TOWN OF BERTHOUD PLANNING COMMISSION

THURSDAY, March 27, 2021

STAFF REPORT, REZONING, NEIGHBORHOOD MASTER PLAN: WESTSIDE CROSSING (FORMERLY SAFEWAY PUD)

DATE: March 27, 2021

ZONING AND PREFFERED LAND USE MAP

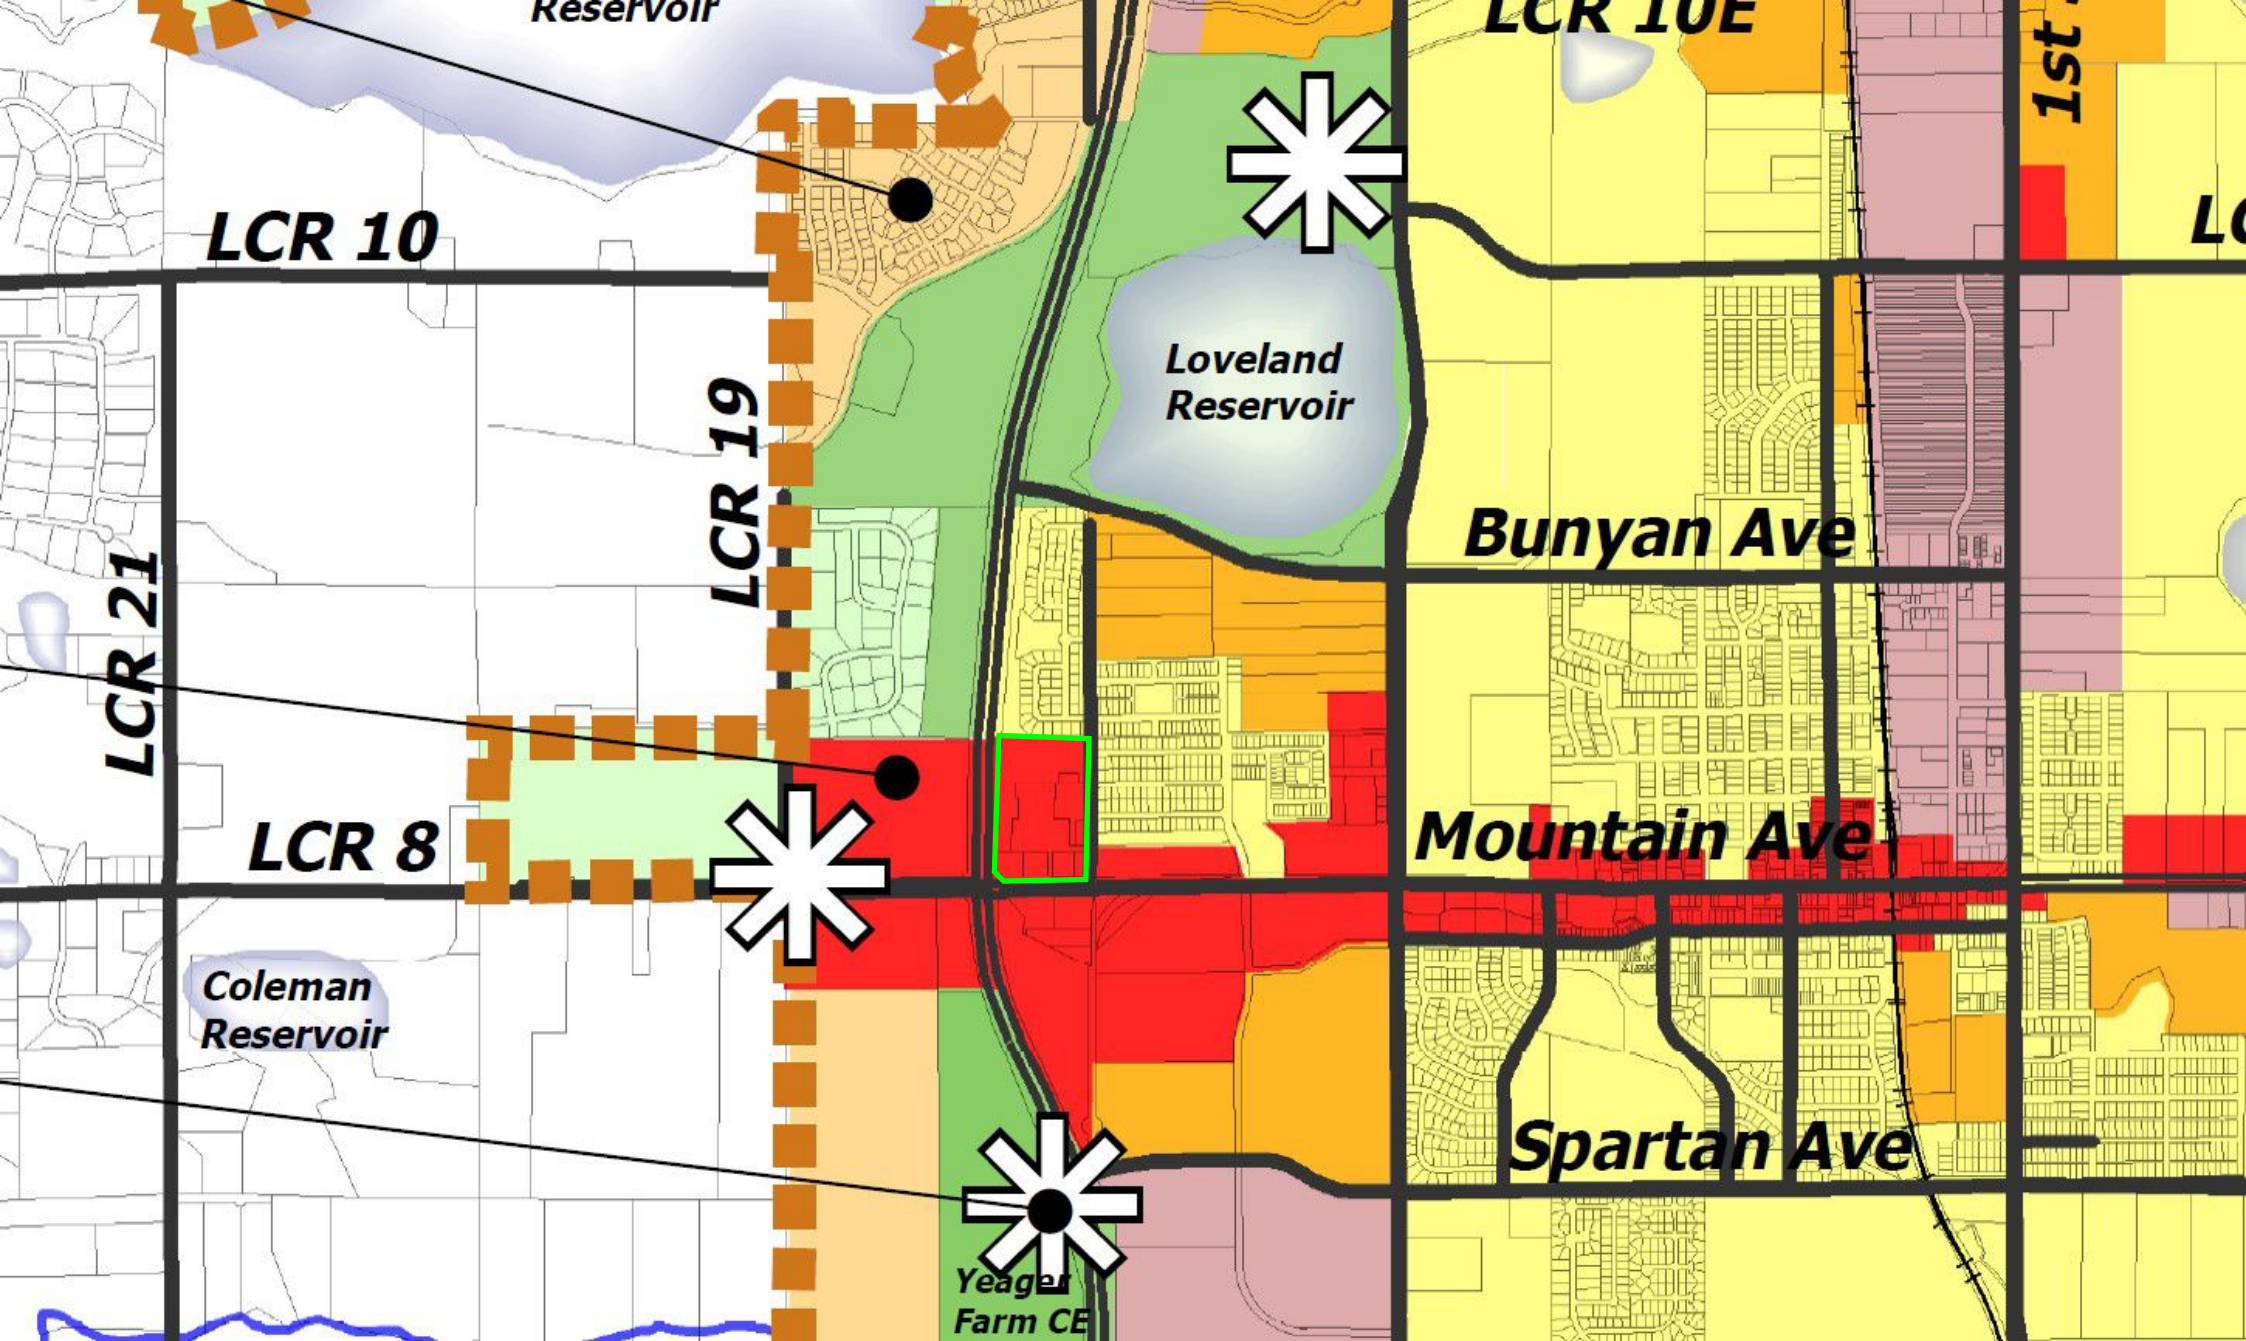
The Town's Preferred Land Use Map designates this area as Commercial (red on the map). The Preferred Land Use Plan was approved in the 2014 Comprehensive Plan.

- ✓ The C-2 Commercial District is consistent with the Comprehensive Plan.
- x. The R-4 rezoning requested is not consistent with the Commercial Preferred Land Use Plan

NEIGHBORHOOD MASTER PLAN - PARK PLAN

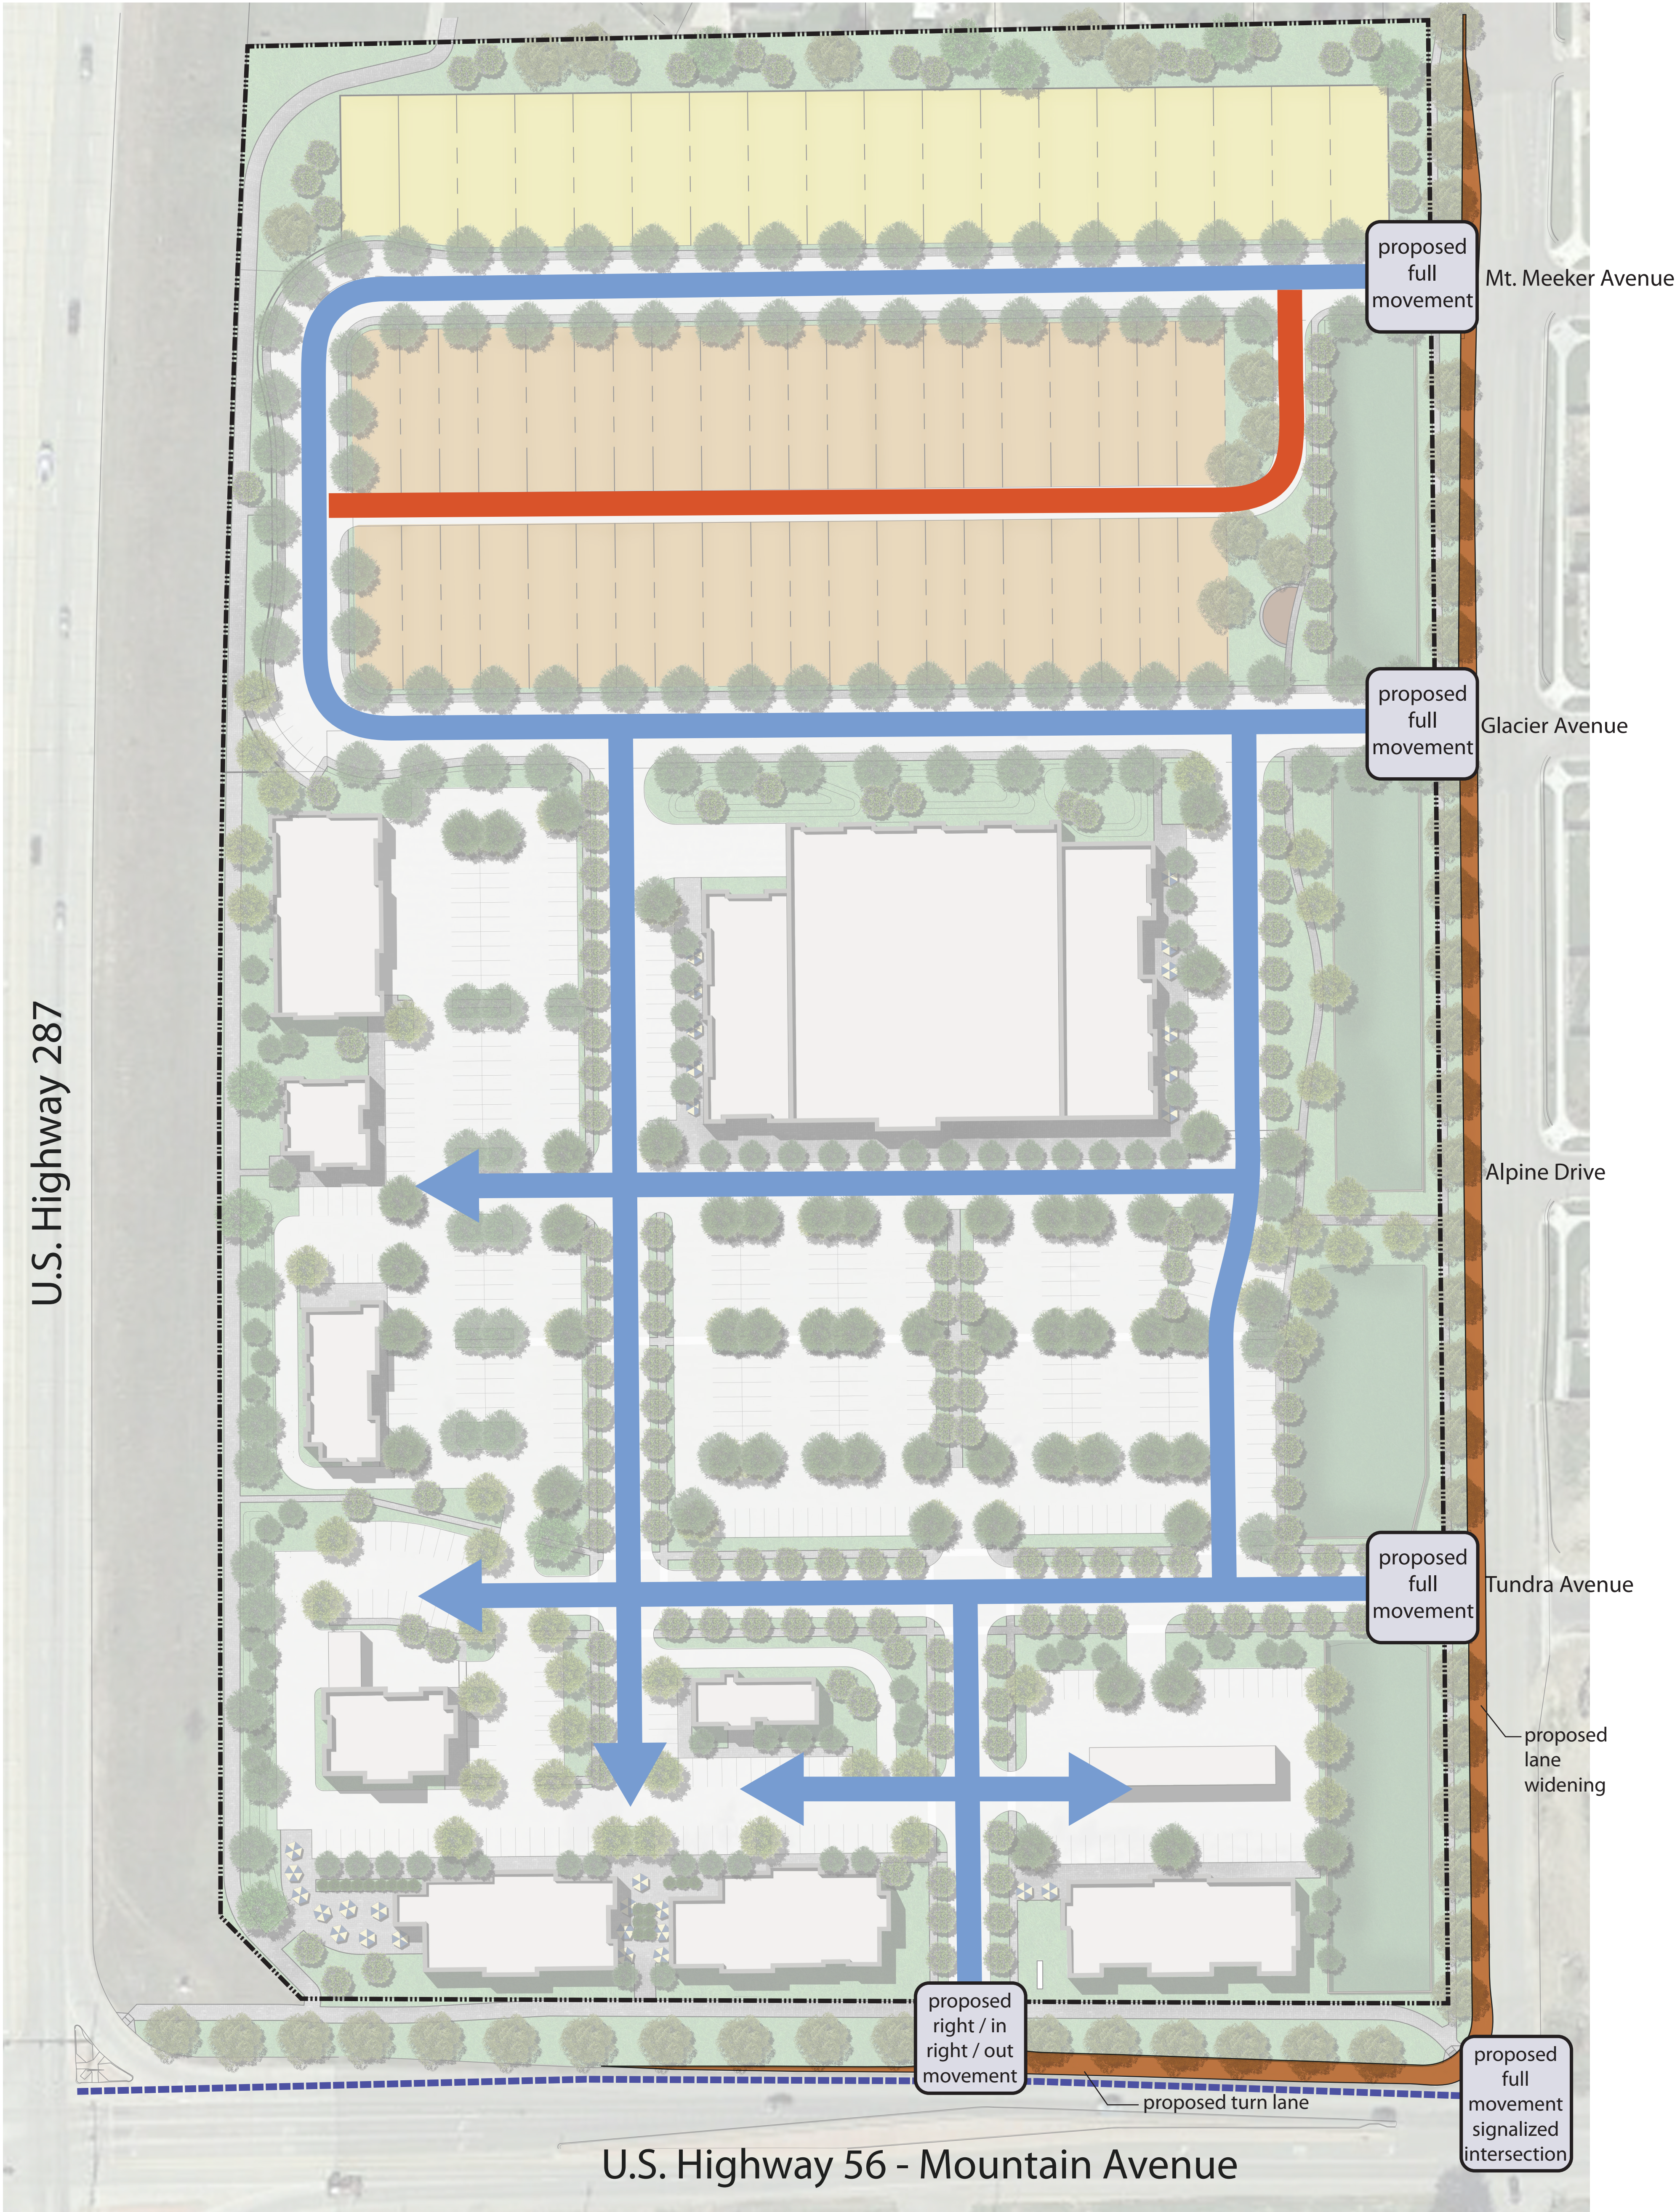
provided will need to be expanded to serve the residential areas, as Section 30-2-109 requires 1 acre of park per 100 dwelling units. This project has a third of an acre park for fifty eight dwelling units.

- x. Additional park land will be required for the residential area should it be approved.

1. Berming and additional landscaping will be required for every site plan along Meadowlark and HWY 287.
2. A 10' trail connection from the trailhead to the HWY 287 must be provided.
3. Additional park area to serve the residential area must be provided as per 30-2-109.
4. The Applicant verify by Preliminary Plat that the detention area is useable for recreational purposes.

NEIGHBORHOOD MASTER PLAN - PEDESTRIAN NETWORK

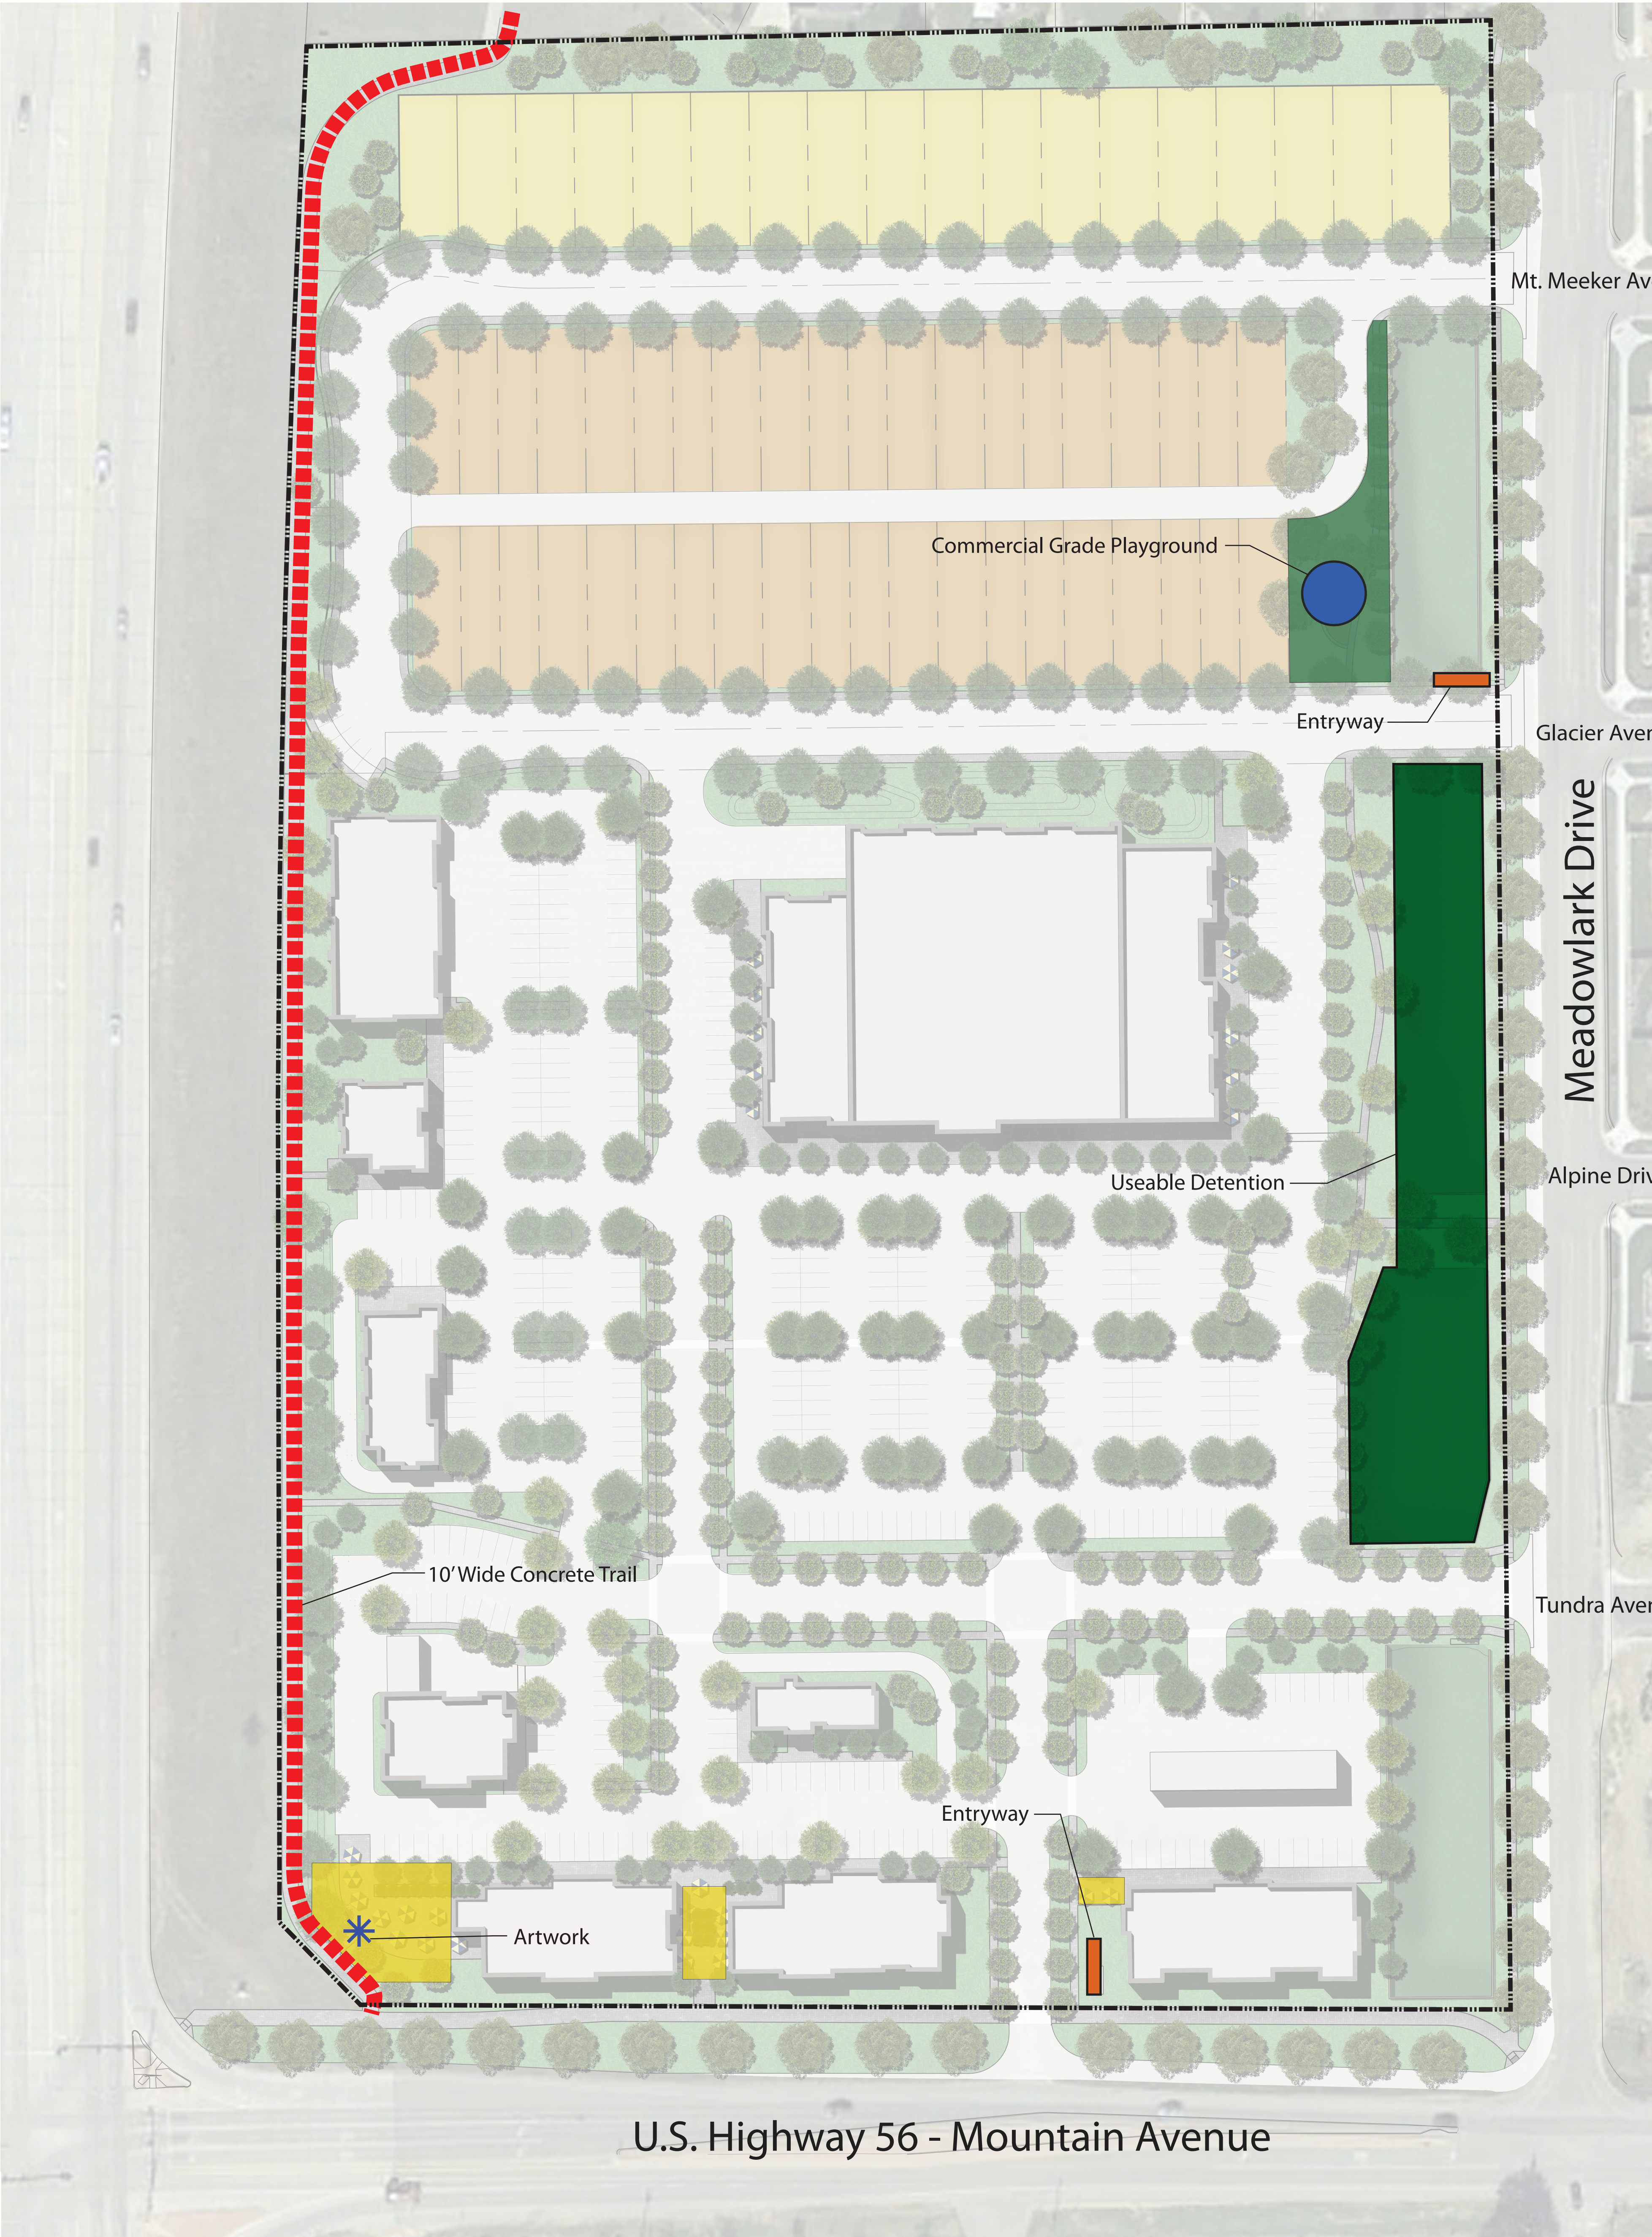
- ✓ The project generally satisfies the requirements of the code.
 - x. Town Staff would recommend a trail connection from the trailhead (not sidewalk, over to the 10' Hwy 287 trail.
